TECHNICAL MEMORANDUM

TO: Dr. Robert Leidy, U.S. Environmental Protection Agency (EPA) Region 9

FROM: Dr. Mathias Kondolf, consulting fluvial geomorphologist, Berkeley, California,
and James Ashby, PG Environmental, LLC, Golden, Colorado

SUBJECT: Conceptual Design for Sonoita Creek, AZ, Technical Review Support (Order
Number EP-G149-00241)

Figure 2a. Hydrologic soil group map and color-coded ratings for Sonoita Creek area (see next page for map legend).

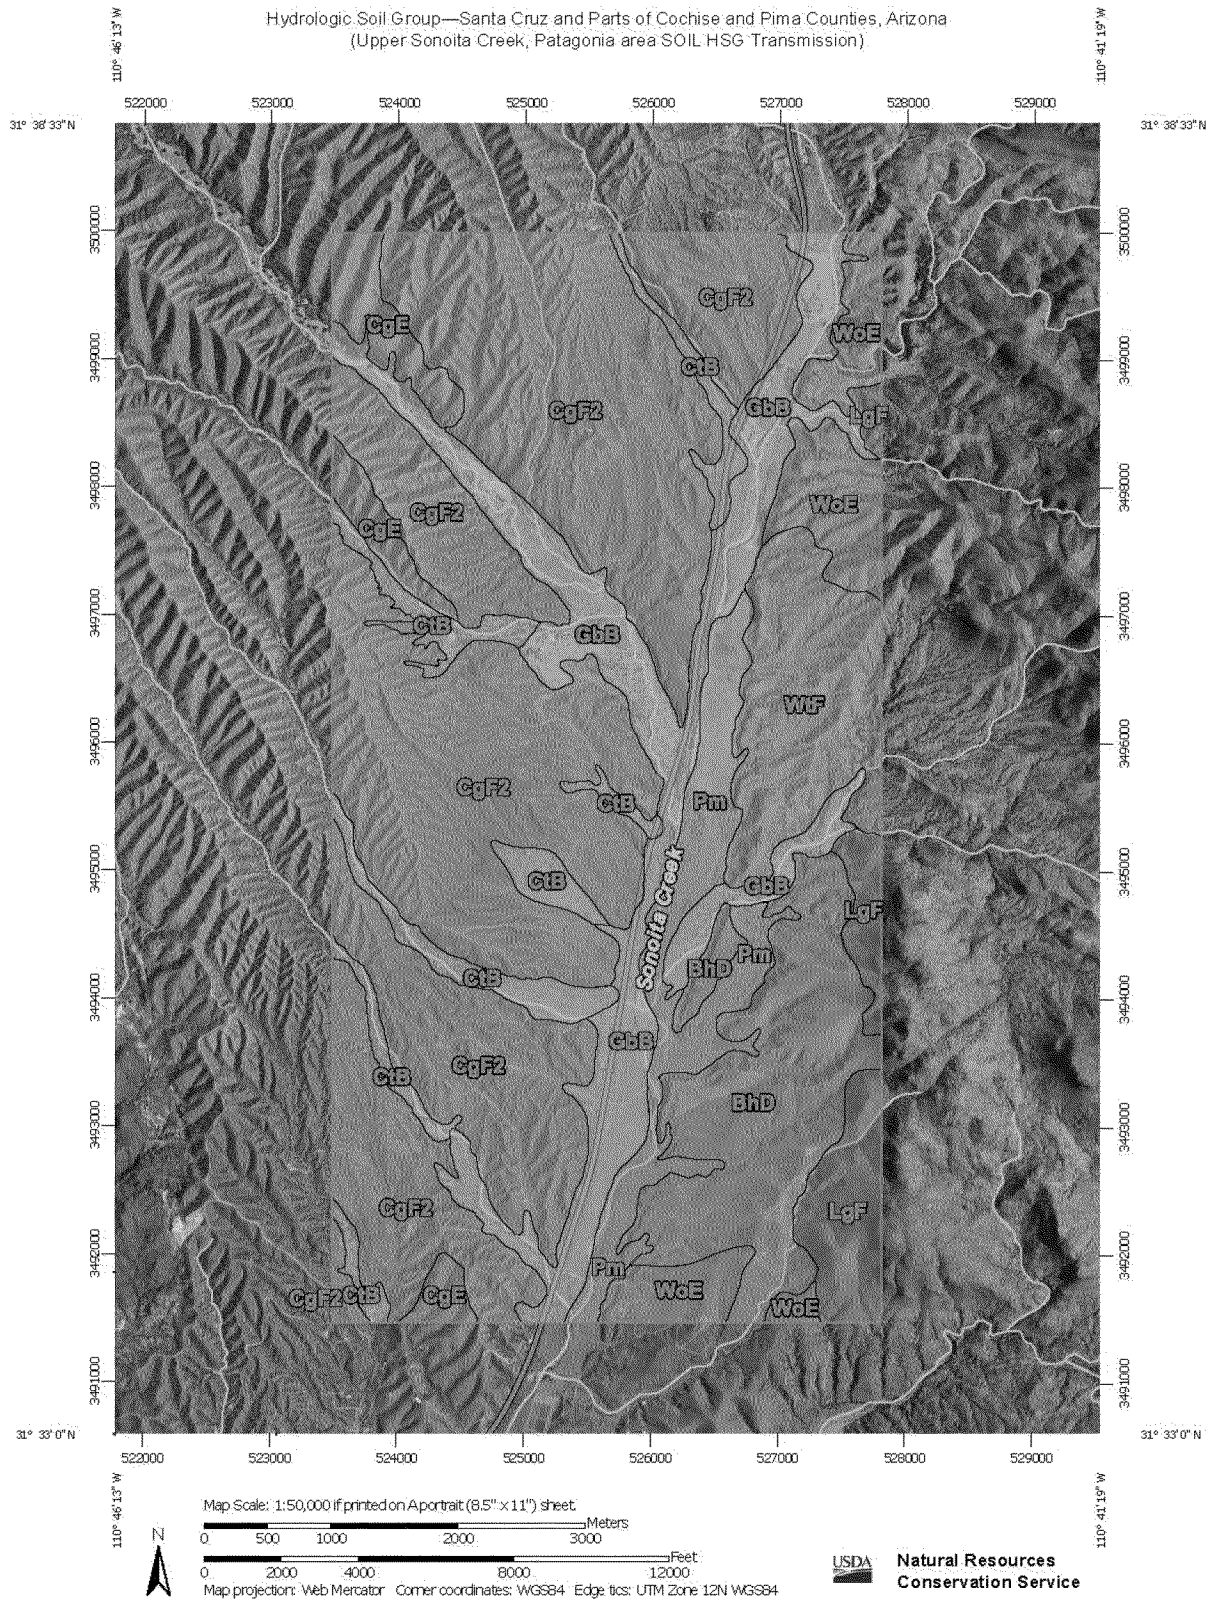
- 3) **The proposed constructed channels will likely not sustain flow in the specific soil types within the project reach.** The Sonoita Creek valley bottom consists primarily of alluvial deposits. In terms of mapped soil units, it is dominated by Grabe-Comoro complex (GbB) soils of gravelly sandy loam to sandy loam composition, that receive a hydrologic soil group classification (HSG) of Group A (refer to Figure 2a and 2b). Group A soils are characterized by high infiltration rates, low runoff potential, and a high rate of water transmission. The Sonoita Creek floodplain also has a lesser percentage of Pima soils (Pm), a clay loam that receives a HSG classification of Group C. Group C soils are characterized by slow infiltration rates and slow water transmission.

Transmission losses due to infiltration into the bed and banks are high in semiarid ephemeral streams, and multiple researchers have demonstrated that except during the highest flows, there is significant loss of in-stream flow due to seepage as the flow proceeds downstream in alluvial valleys (Levick, et al. 2008). The WET report (p.12) notes that transmission losses for streams like Sonoita Creek have been reported as high as 17-29%. Approximately half of the constructed pilot channels as proposed in the plan would be excavated into the highly permeable Grabe-Comoro complex soils, resulting in high transmission losses. Any portion of the flow that entered the newly constructed channels during low to moderate flow rate events, such as those that occur at a high frequency annual scale, would likely not be sustained, and likely not return to the main Sonoita Creek channel. Sediment drops out of suspension as infiltration occurs and flow drops in velocity, depositing new material in the channel. Resulting aggradation may fill the newly constructed channels, further restricting the ability of flows to be diverted and for any diverted flow to successfully return to the main Sonoita Creek channel, particularly at the downstream reaches of constructed channels. Continued aggradation in the constructed channel could eventually create an abandoned, non-functional channel. The overall result would be a loss of habitat in the main channel of Sonoita Creek and a failure to create new habitat in the constructed channels, therefore failing to meet the stated goals of the proposed design in the WET report.
